Central Zoo Authority

F. No. 19-45/92-CZA(328)(Vol.IV)(M)

Sub:- Development of Zoological Garden, Alipore - Regarding.

The designs of the following proposed development work at Zoological Garden, Alipore were scrutinized by the Expert Group on Zoo Designing in its meeting held on 23rd December, 2009. The designs are approved subject to the following modifications:-

SCHEME PROPOSAL FOR MODIFICATION OF REPTILE HOUSE, Alipore Zoological Garden, Kolkata

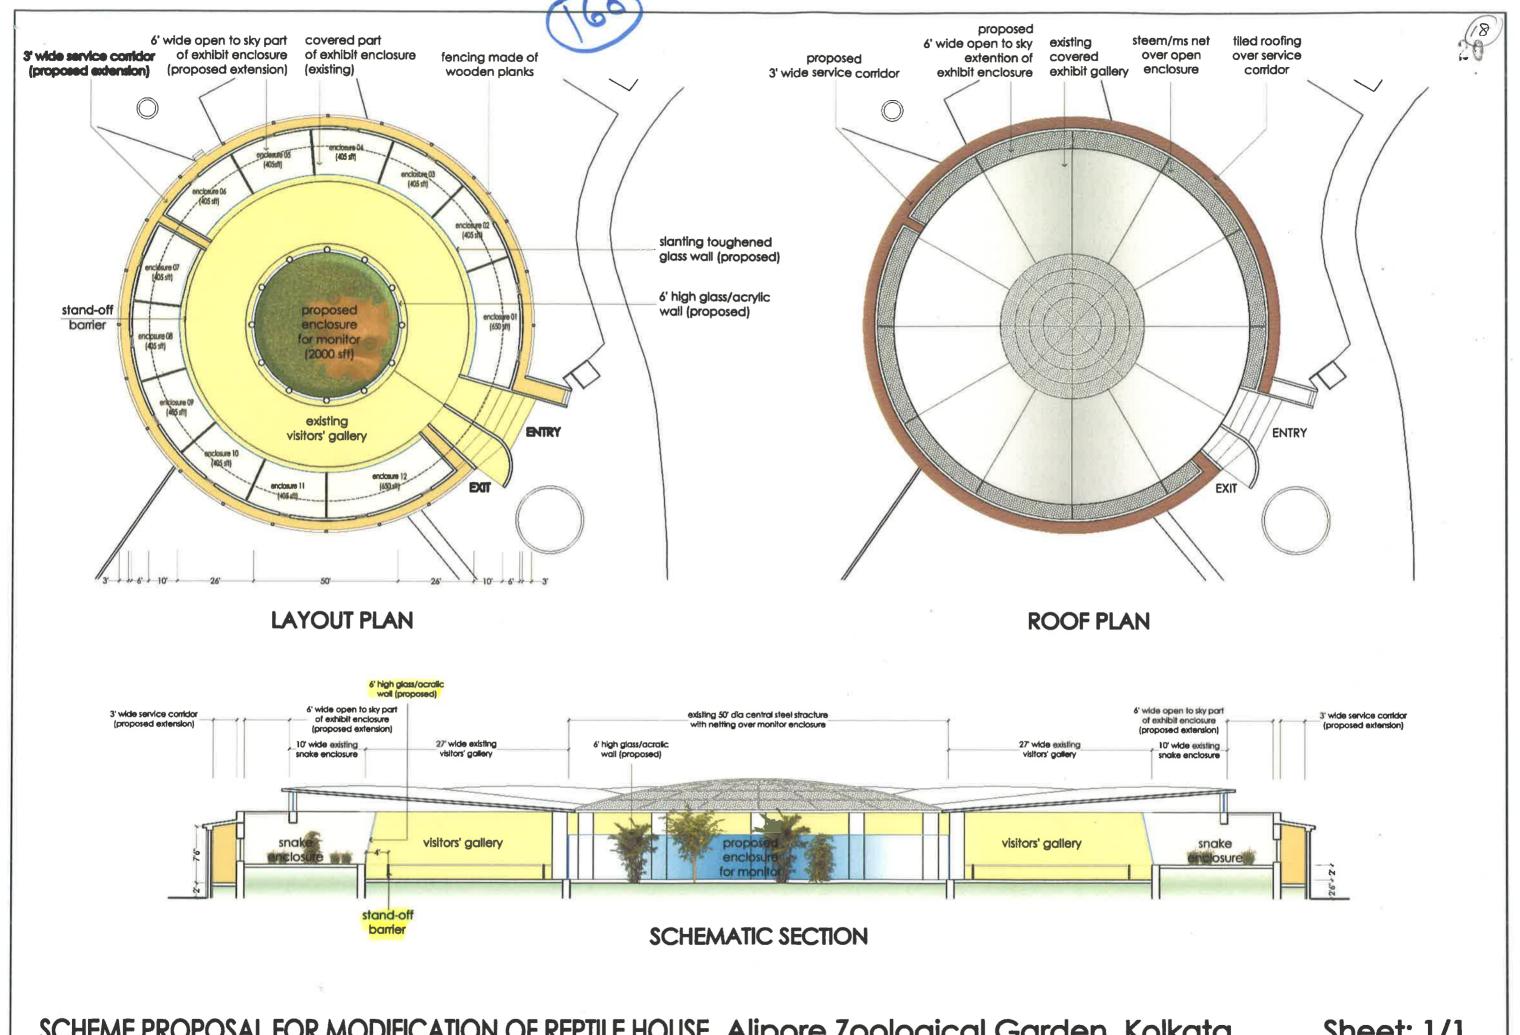
(ii) Modification/ renovation of Reptile house

(a) The glass at viewing site of the enclosure should be large and inclined inwards to prevent reflection.

(b) Appropriate stand off barrier may be provided to prevent visitors from touching the glass.
